## IMPORTANT NOTICE

These instructions are designed to be used in conjunction with the Mini Mach/Super Mach air conditioner kit, part number 4737G8091.

Effected Models: All 1993 Cape Cod model trailers  
All 1993 Rio Grande model trailers

DETAIL FOR INSTALLATION OF GRAY BUMPERS  
ONTO CURBSIDE REAR WINDOW WHEN A/C IS INSTALLED

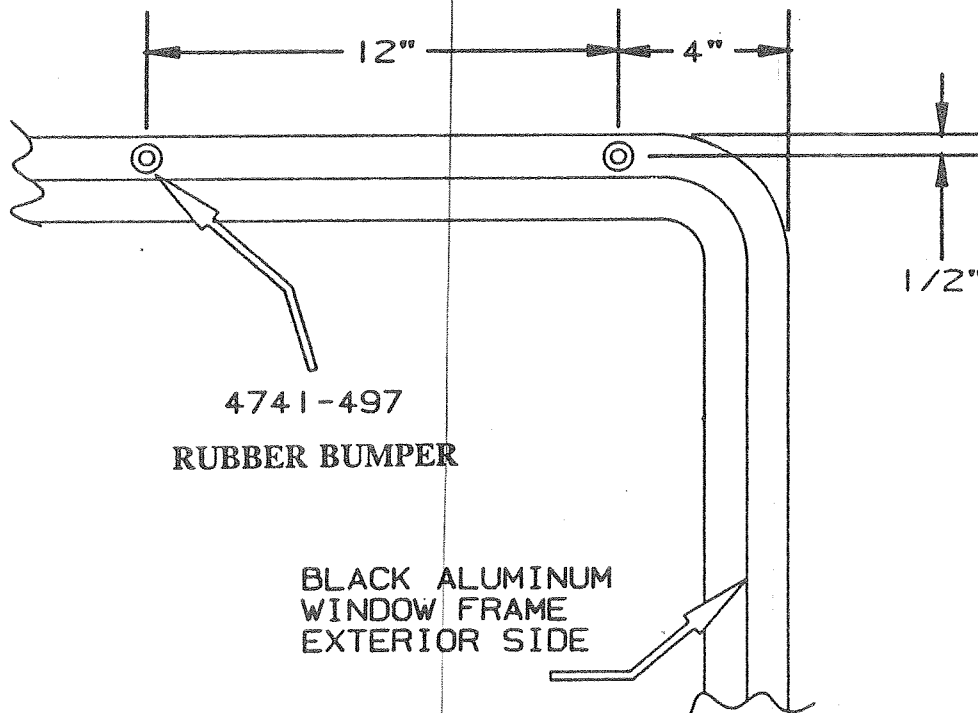
Upon completion of the installation instructions included with each Mini-Mach/Super-Mach air conditioner kit, two grey, rubber, dimpled bumpers must be adhered to the curbside, rear window metal frame as shown in the figure below. The rubber bumpers will keep the curbside hardwall from rubbing against the ceiling assembly shroud during transit.
